**Updated Response to Request for Additional Information
Specific to the Electric Power Research Institute Report 1025203,
"Utilization of the EPRI Depletion Benchmarks for Burnup Credit Validation"**

NRC Questions and Responses:

Figure 1-1: Energy Spectrum Index (EALF) of the Benchmarks and Typical Racks as a Function of Burnup

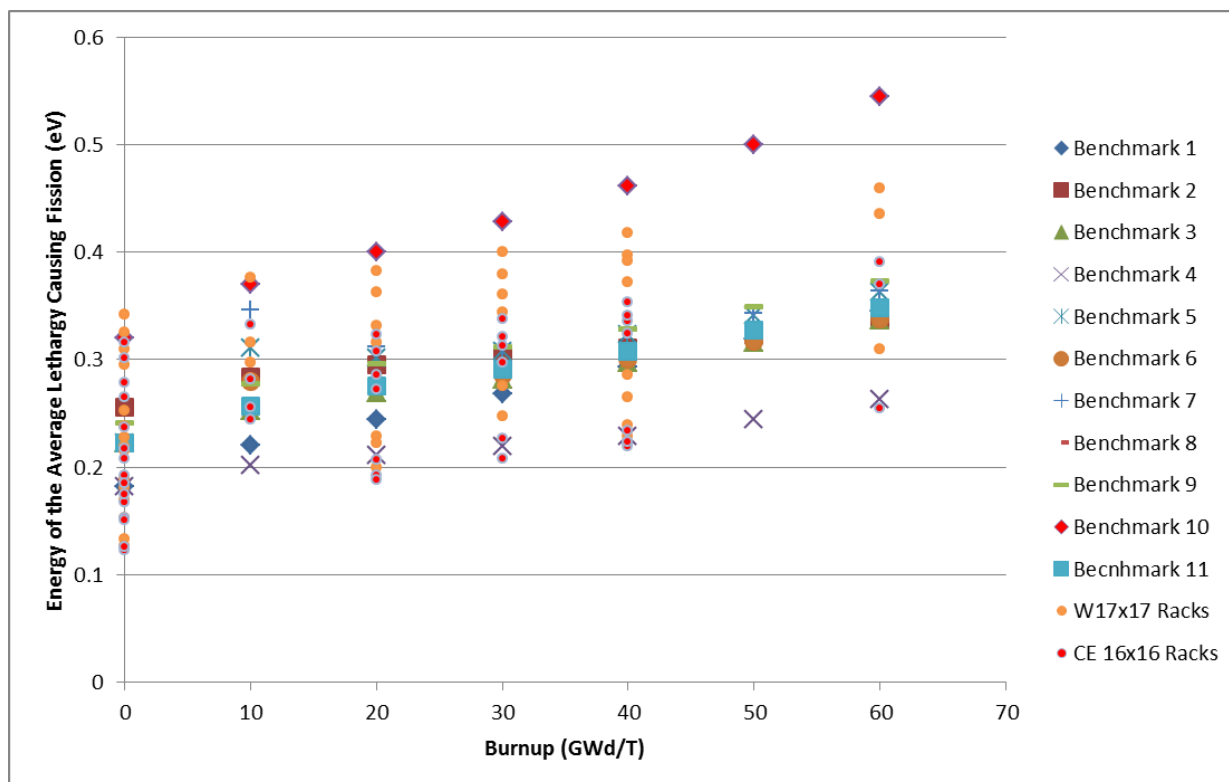
1. In Section 2, it is stated that, "In particular, it is important to assure that the neutron energy spectrum for the critical system is bounded by the neutron energy spectrum in benchmarks used for the determination of Δk_d ." With the large variation in possible Spent Fuel Pool (SFP) configurations, how is it ensured that the neutron energy spectrum in benchmarks used for the determination of Δk_d are similar (or bound) the neutron energy spectrum for all possible critical systems?

The term "bounded by" in Section 2 should be replaced with "representative of" as it is not likely that all the possible spectrums in the SFP will be strictly bounded by the set of 11 benchmarks. However, the particular benchmarks included were selected to provide a range of spectra that are representative of the spent fuel pool environment. Figure 1.1 demonstrates this pictorially, where the Energy of the Average Lethargy causing Fission (EALF) for the benchmarks is compared to the EALF from a range of typical SFP racks as a function of burnup. It is observed that the hardest spectrum is from Benchmark 10, which contains 1500 ppm soluble boron as it has the highest EALF of all benchmark cases at all burnups. The softest spectrum is from Benchmark 4, which uses the OFA fuel pin design as it has the lowest EALF of all benchmark cases at all burnups. The same rack and fuel configurations, 56 cases in total, used in the previous EPRI sensitivity studies [2] are used for the analysis. The key parameters for rack descriptions are provided in the first few rows of Table GR-1. As evident from the points plotted in Figure 1.1, the benchmarks bound the majority of the spent fuel rack configurations and are representative of all configurations. The prime exception where the benchmarks do not necessarily "bound" the typical rack configurations is in the fresh fuel cases (zero burnup), where the spectrum is much softer than what the benchmark cases represent. However, the benchmarks were chosen with the intent to represent the spectrum associated with spent fuel for quantification of the depletion uncertainty and the fresh fuel configuration is already covered by the fresh fuel benchmarks that are addressed in NEI 12-16 [6].

Figure 3-1 HZP to HFP Bias as a Function of Burnup

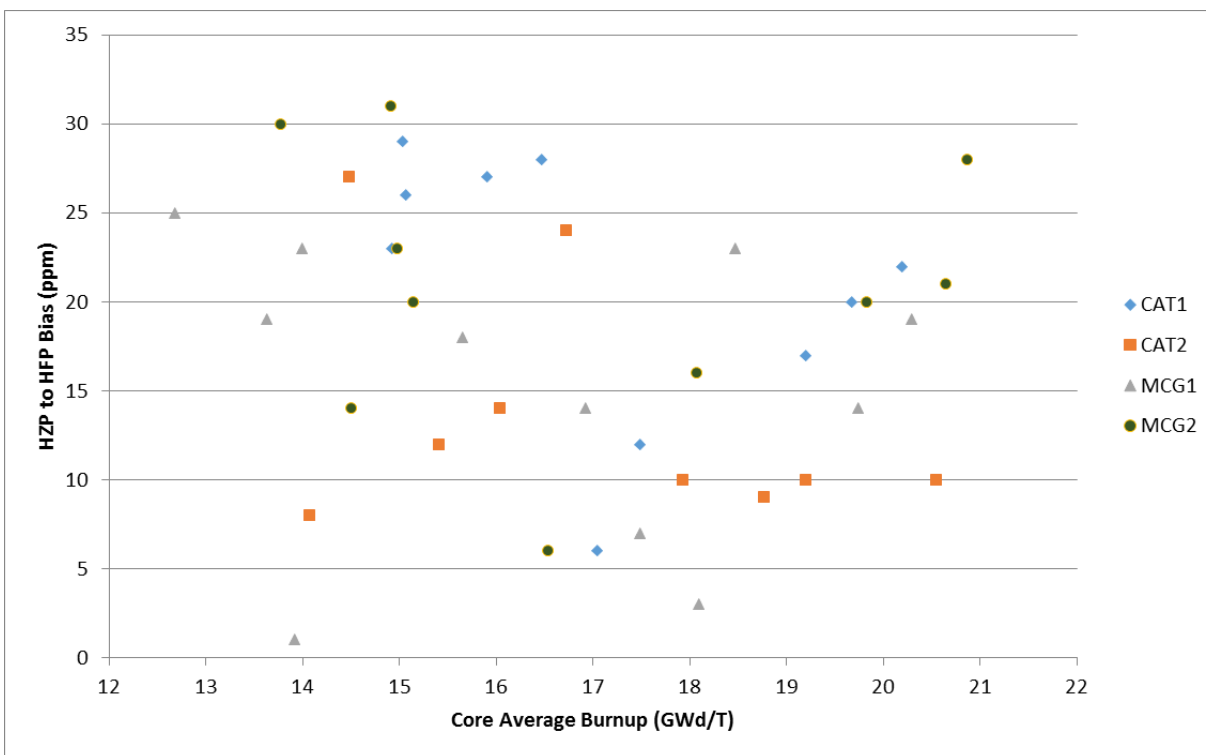
3. EPRI Report 1025203 bases the 11 benchmark criticality case bias and uncertainty estimates, intended to cover reactivity calculations in SFP conditions, on bias and uncertainty estimates inferred from HFP operating reactor measurements. Application of bias and uncertainty in this manner requires bias and uncertainty extrapolation in time (decay), fuel temperature, moderator temperature, etc. Provide additional discussion on the basis for the bias and uncertainty, and justification for the limitations and assumptions associated with the following conditions:
 - a. an extension of operating reactivity measurements to 100 hours (Were restart critical configurations considered?),

The uncertainty in going from HFP to cold rack conditions at 100 hours is conservatively assessed as 452 pcm (Table 8-10 of the Benchmark report) as presented in Section 8.5 and 8.6 of the Benchmark report [1]. This assessment was made assuming the uncertainty is dominated by the uncertainty in the cross section library and TSUNAMI was used to propagate the cross section uncertainty.

Although agreement with HZP startup data was not used directly in the assessment of the bias and uncertainty in going from HFP to cold conditions at 100 hours, the performance of CASMO-4/SIMULATE-3 in predicting reactor conditions are shown in Section 5.4 of the Benchmark report. Tables 5-3 through 5-6 of the Benchmark report show the agreement between measured and predicted BOC HZP and HFP critical soluble boron concentrations and the agreement between measured and predicted EOC HFP critical soluble boron concentrations. The difference between the third from the last column and the second from the last column is a HZP to HFP bias in the CASMO-4/SIMULATE-3 system. Figure 3.1 below plots this bias as a function of the BOC core average burnup. There is a HFP to HZP bias of about 17 ppm. It is assumed that this bias is not burnup dependent. Using the general rule of thumb equating 1 ppm to 9 pcm, 17 ppm results in about 150 pcm effect in reactivity. This ~150 pcm is well within the claimed total hot to cold uncertainty of 453 pcm.

The restart critical configurations were not considered in the determination of the bias and uncertainty.
